Product Change Notification

Bourns® Model 3224 and 3214 5-Turn Trimpot® Trimming Potentiometers

Packaging Reel Change

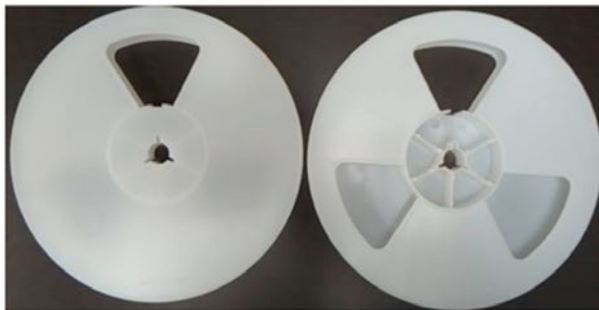
Bourns will be updating the packaging reel for the 4 mm [Model 3224](#) and the 4 mm [Model 3214](#) Trimpot® Trimming Potentiometers. No change is being made to the Model 3224 or Model 3214 products themselves. The change in packaging reels will provide standardization of the packaging for all 4 mm styles. These models, produced in Costa Rica, will begin utilizing reel packaging for styles J, G, W, and X from the current RE 7" reel to the RJ 7" reel. The RJ 7" reel is already being used for the same product produced in Taiwan. The two reel types are similar except for different cutout shapes as shown in the photos below. The reels will continue to be shipped in a protective cardboard box.

Deliveries utilizing RJ 7" reels will begin: May, 2017

First date code using the RJ 7" reels: 1718
